Errata to MPC8548E PowerQUICC III Integrated Host Processor Family Reference Manual, Rev. 2

This document describes corrections to the *MPC8548E PowerQUICC III Integrated Host Processor Family Reference Manual*, Revision 2. For convenience, the section number and page number of the errata item in the reference manual are provided. Items in bold are new since the last revision of this document.

Figure 5-3. MU Pipeline, Showing Divide Bypass

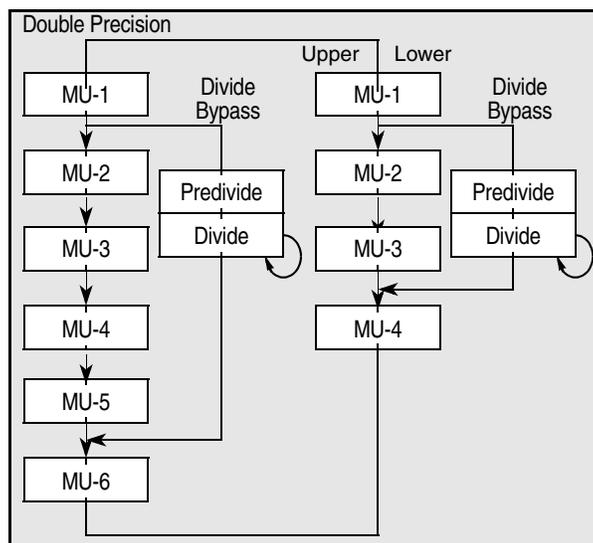
Modify Figure 5-3, “Four-Stage MU Pipeline, Showing Divide Bypass,” and change title to “MU Pipeline, Showing Divide Bypass,” as follows:

Figure 14-110. RQPRM Register Definition

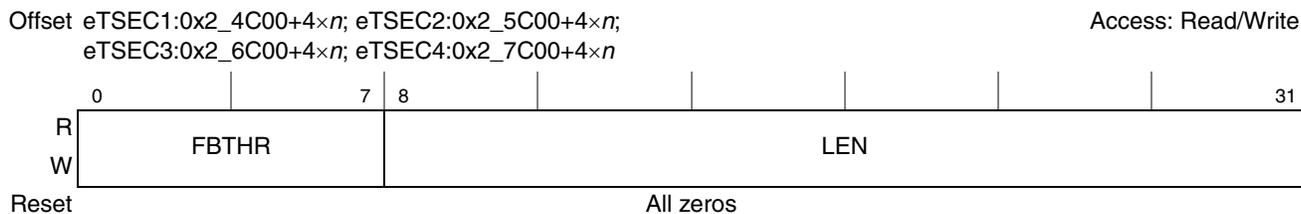
14.5.3.10.2, 14-112 Add [Section 14.5.3.11, “Lossless Flow Control Configuration Registers,”](#) describing lossless flow control registers, as follows:

Figure 14-109. ATTRELI Register Definition

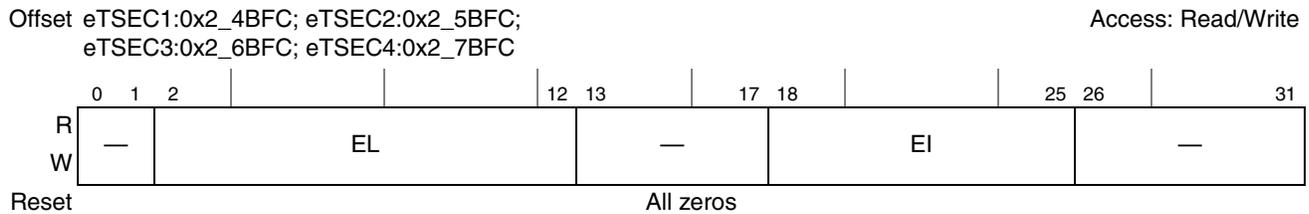
14.5.3.10.2, 14-113 In Figure 14-109, “ATTRELI Register Definition,” and Table 14-112, “ATTRELI Field Descriptions,” change size of AEI field. The updated register definition and field description appear as follows:

Figure 15-25. Source/Destination Engine Transaction Size Flow Chart

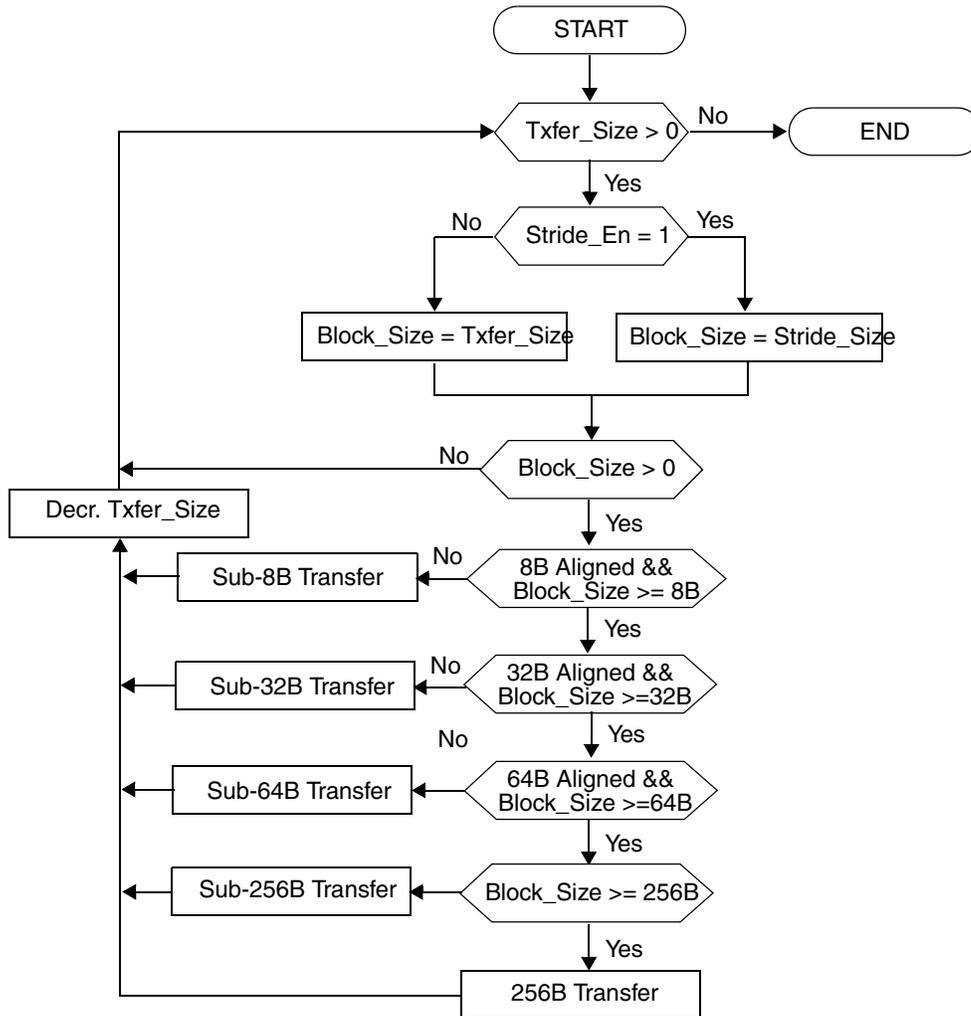
15.4.1, 15-29	Add Section 15.4.1.1, “Source/Destination Transaction Size Calculations,” as follows:

Figure 17-48. Physical Configuration Register (PCR)

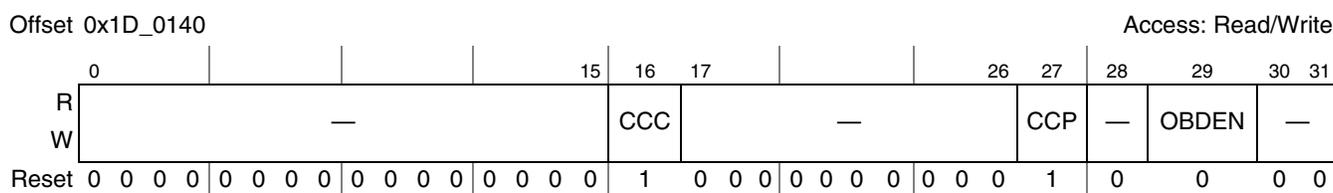
In Figure 17-48, “Physical Configuration Register (PCR),” CCP should be represented as a read/write bitfield. The updated definition appears as follows:

Figure 18-68. PCI Express Prefetchable Memory Base Register

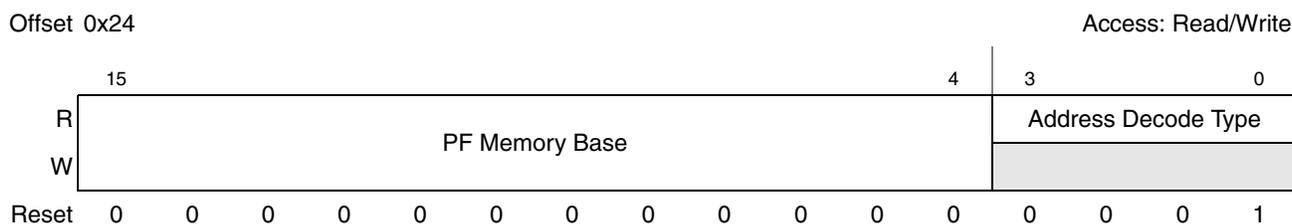
18.3.8.3.11, 18-62 Replace Figure 18-68, “PCI Express Prefetchable Memory Base Register,” with the following:

Figure 18-69. PCI Express Prefetchable Memory Limit Register

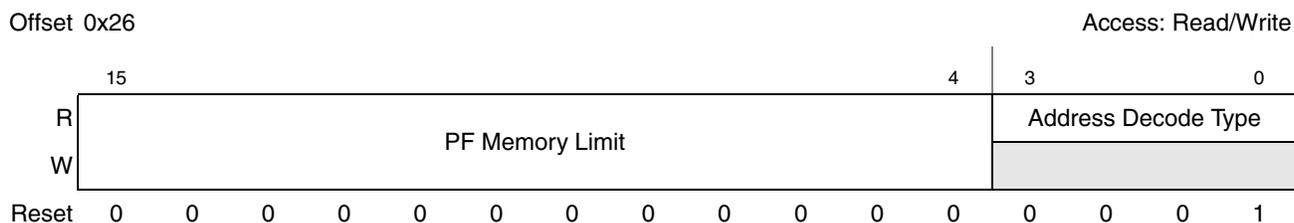
18.3.8.3.12, 18-63 Replace Figure 18-69, “PCI Express Prefetchable Memory Limit Register,” with the following:

Figure 18-106. PCI Express Correctable Error Status Register

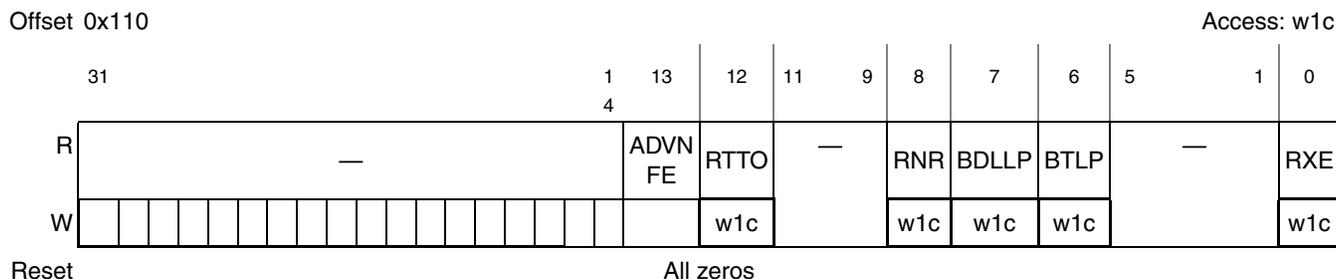
- 18.3.10.5, 18-84** Replace Section 18.3.10.5, “PCI Express Correctable Error Status Register—0x110,” with the following:

Figure 18-107. PCI Express Correctable Error Mask Register

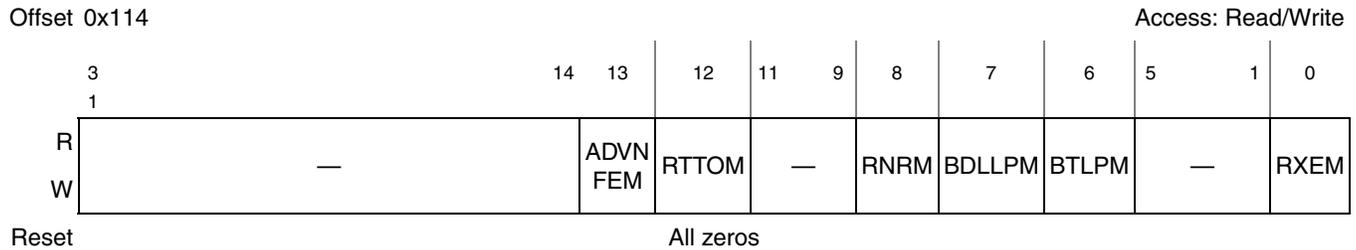
18.3.10.5, 18-85 Replace Section 18.3.10.5, “PCI Express Correctable Error Mask Register—0x114,” with the following:

Figure 20-1. POR PLL Status Register (PORPLLSR)

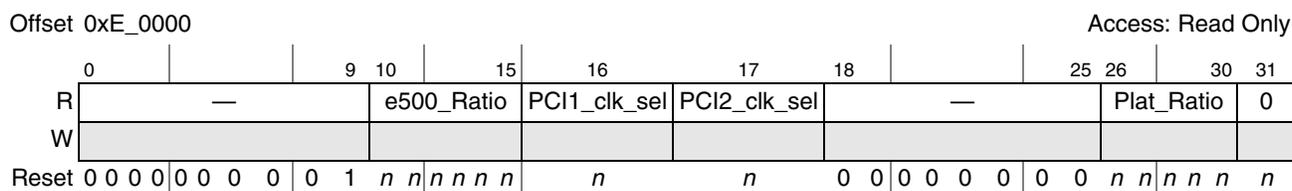
20.4.1.1, 20-5 In Figure 20-1, “PORPLL Status Register (PORPLLSR),” change reset value for bits 8–9 to from “00” to “01,” as follows:

Figure 20-25. SerDes Control Register 1 (SRDSCR1)

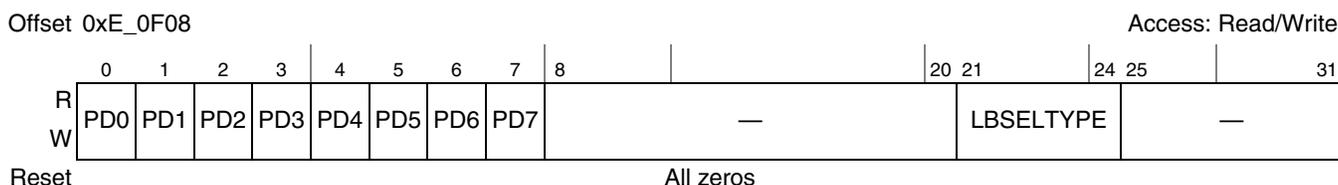
20.4.1.25, 20-27 Add field SRDSCR1[LBSSELTYPE] in Figure 20-25, “SerDes Control Register 1 (SRDSCR1),” and its corresponding field description in Table 20-28, “SRDSCR1 Field Descriptions.” The register figure and field description table changes should appear as follows:
